RB197-06/07

R602.10.3.1 (New)

RB207-06/07

RB209-06/07

**FIGURE R602.10.5(2)
WALLS WITH 6:1 ASPECT RATIO USED WITH CONTINUOUS WOOD STRUCTURAL PANEL SHEATHING**

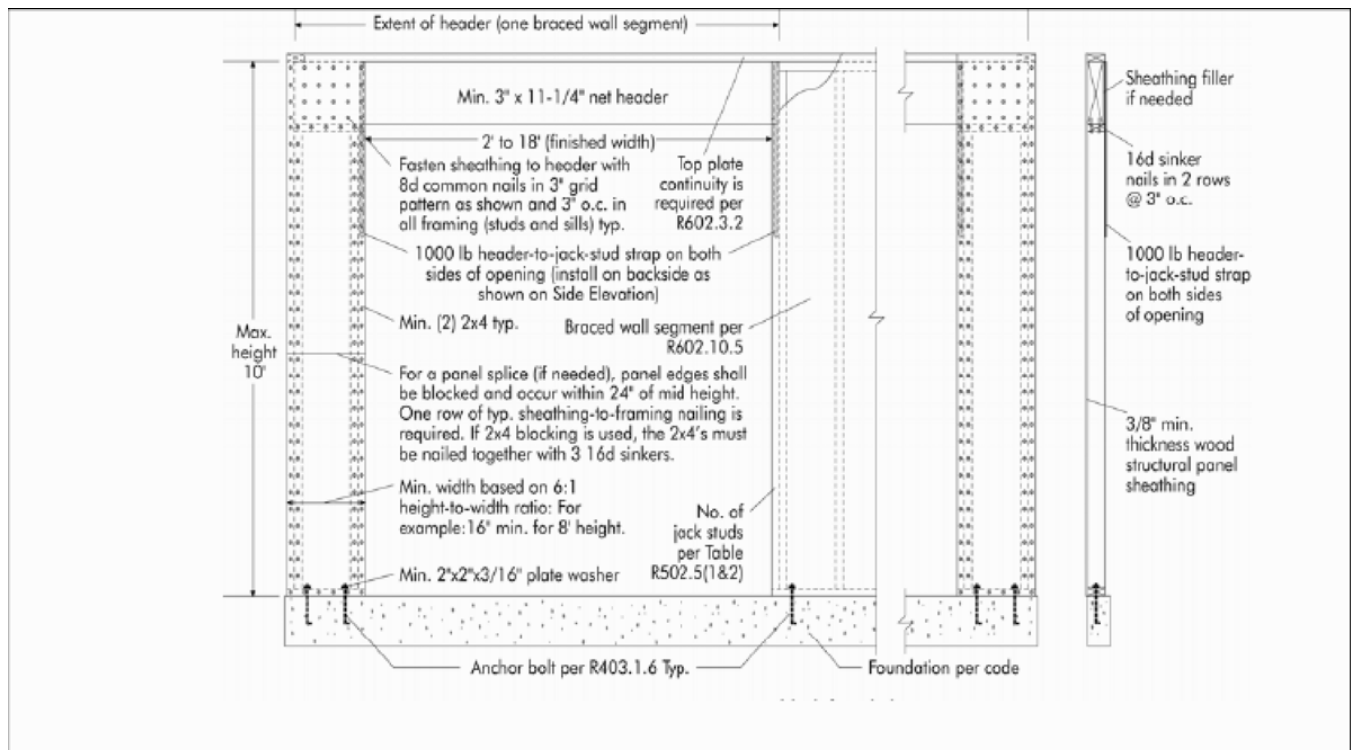
3. Add new Figure R602.10.5(2) and renumber Figure R602.10.5 to R602.10.5(1):

RB207 As modified - New Figure R602.10.5(2) Walls with 6:1 aspect ratio used with continuous wood structural panel sheathing:

Min. ~~width~~ length based on 6:1 height-to-width ratio: For example: 16” min. for 8’ height

**FIGURE R602.10.5(1)
TYPICAL CONTINUOUSLY-SHEATHED BRACED WALL LINE**

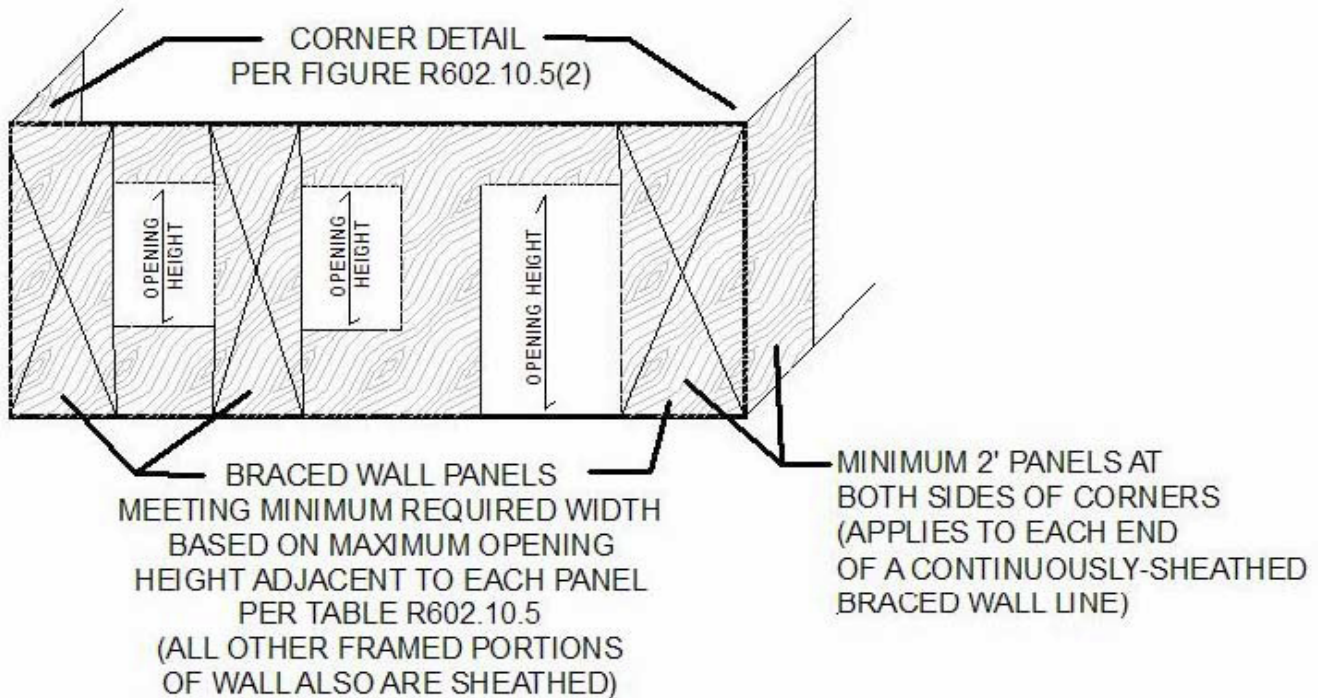
R602.10.5.1 Continuously-sheathed braced wall line requirements. Continuously-sheathed braced wall line shall be in accordance with Figure R602.10.5(1) and shall comply with all of the following requirements:

Delete Figure R602.10.5(1) and replace with the new Figure R602.10.5(1) as follows:

Commenter's Reason: The Ad Hoc Committee on Wall Bracing has further reviewed the figure that was approved as part of the modification and recommends replacement for consistency with the package of bracing provisions. This replacement figure retains the key illustrations of: the entire wall being sheathed; the corner detail being illustrated; and the reference to the applicable section for the bracing requirements. This figure differs from the original figure as follows: clarifies that the opening height is a clear opening height for purposes of the application of provisions; eliminates unnecessary corner detail information as this is covered in the referenced figure; and uses the revised terminology of bracing "length" versus "width".

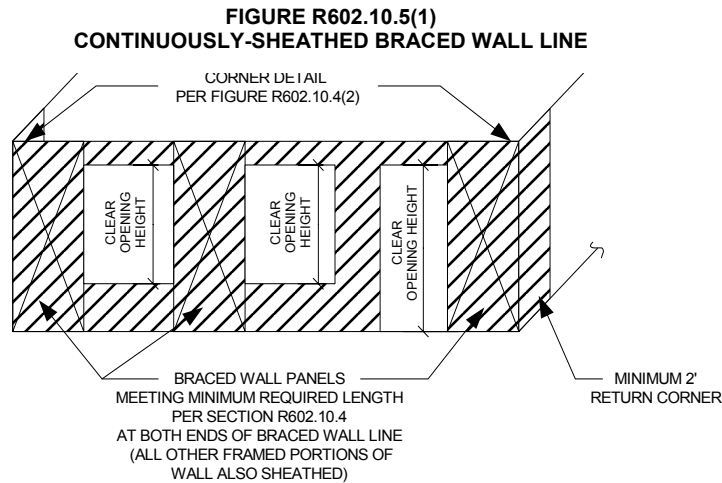
The only change to Section R602.10.5.3 is the revision of the length of the first bracing panel from the end from 12 feet to 12 feet 6 inches. This is merely a coordination change with the approved text in Section R602.10.1.2 from RB179.

The changes to Section R602.10.5.4 are also coordination changes. This text is coordinated with the approved text from code change RB205 which refers to "other bracing adjustments" and RB207 where Section R602.10.5.1 stipulates the multiplication factors for wall opening height. This text is coordinated with the approved Table R602.10.4(1) from RB 179 which is a tabular form of identifying the wall height adjustment factors.

FIGURE R602.10.5(1)
CONTINUOUSLY-SHEATHED BRACED WALL LINE-WITHOUT CORNER RETURN

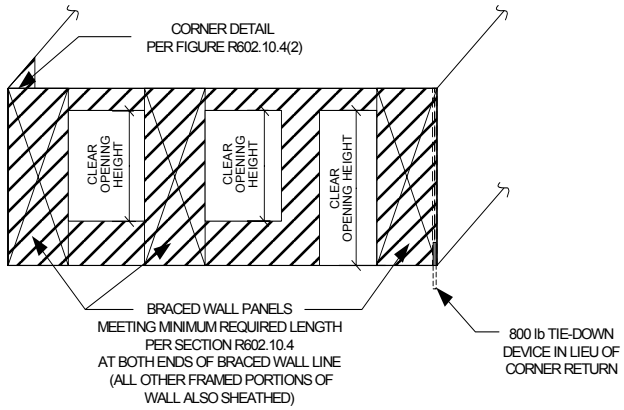
R602.10.5.3 Braced wall panel location and corner construction. A braced wall panel shall be located at each end of a continuously-sheathed braced wall line. A minimum 24-inch wood structural panel corner return shall be provided at both ends of a continuously-sheathed braced wall line in accordance with Figure R602.10.4.3 In lieu of the corner return, a tie-down device with a minimum uplift design value of 800 lb shall be fastened to the corner stud and to the foundation or framing below in accordance with Figure R602.10.5.3 (1).

Add new figures as shown:

Commenter's Reason: The proposed public comment adds 3 new figures to help the code user understand the intent of the continuous sheathing requirements. Given the recent history of issues with interpretation of this section of the IRC, the ICC Ad Hoc Committee on Wall Bracing believes that figures are needed to complement the text with simple visual examples. The figures are developed to show continuous braced wall lines with various options for anchoring the first braced wall panel. Furthermore, the style of the proposed figures is consistent with the graphics in RB179 -- a complete reformat of the wall bracing provisions. The proposed modification does not change any requirements previously approved by the IRC Code Development Committee at the hearings in Orlando in September 2006.

FIGURE R602.10.5.3(3)
CONTINUOUSLY SHEATHED BRACED WALL LINE – FIRST BRACED
WALL PANEL AWAY FROM END OF WALL LINE WITH TIE DOWN

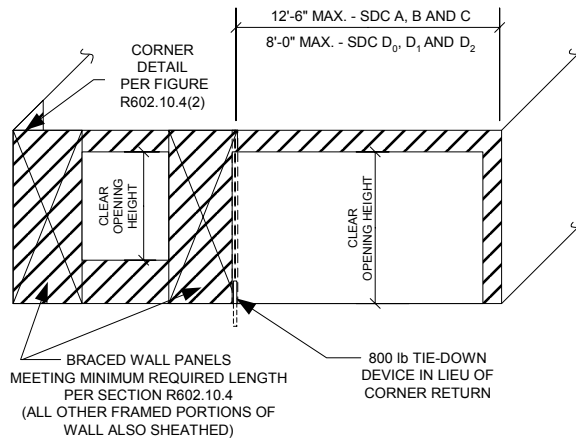
1. A minimum 2-foot-long, full-height wood structural panel is provided at both sides of a corner constructed in accordance with Figure R602.10.5 at the braced wall line ends in accordance with Figure R602.10.5.3(2), or
2. The braced wall panel closest to the corner shall have a tie-down device with a minimum uplift design value of 800 lb fastened to the stud at the edge of the braced wall panel closest to the corner and to the foundation or framing below in accordance with Figure R602.10.5.3 (3).
